CITY OF ST. LOUIS
**PLANNING & URBAN
DESIGN AGENCY**
CULTURAL RESOURCES OFFICE
FRANCIS G. SLAY, Mayor

DATE: November 28, 2016
ADDRESS: 1708-26 Park Avenue
ITEM: Preliminary Review: Construct a three-story apartment building
JURISDICTION: Lafayette Square Certified Local Historic District — Ward 7
STAFF: Jan Cameron, Cultural Resources Office

1708-26 PARK AVENUE

FRONT (PARK AVENUE) ELEVATION

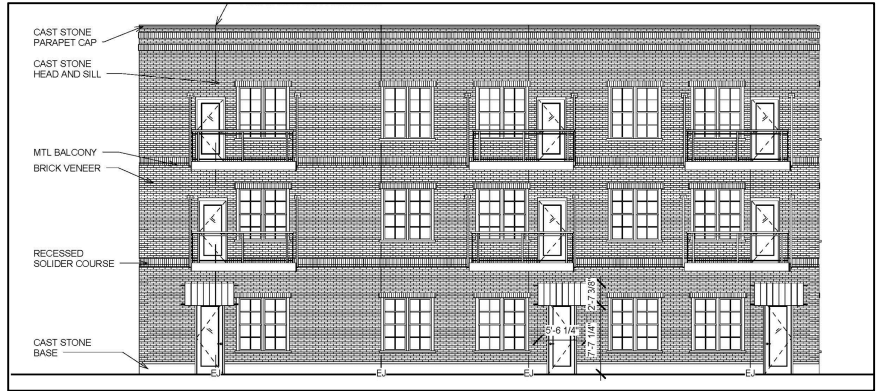
Fenestration on the proposed building does not follow the HME exactly, but instead presents a generic interpretation of 19th century factory buildings. The front elevation has recessed balconies which are not present on the Bouras Mop Factory.
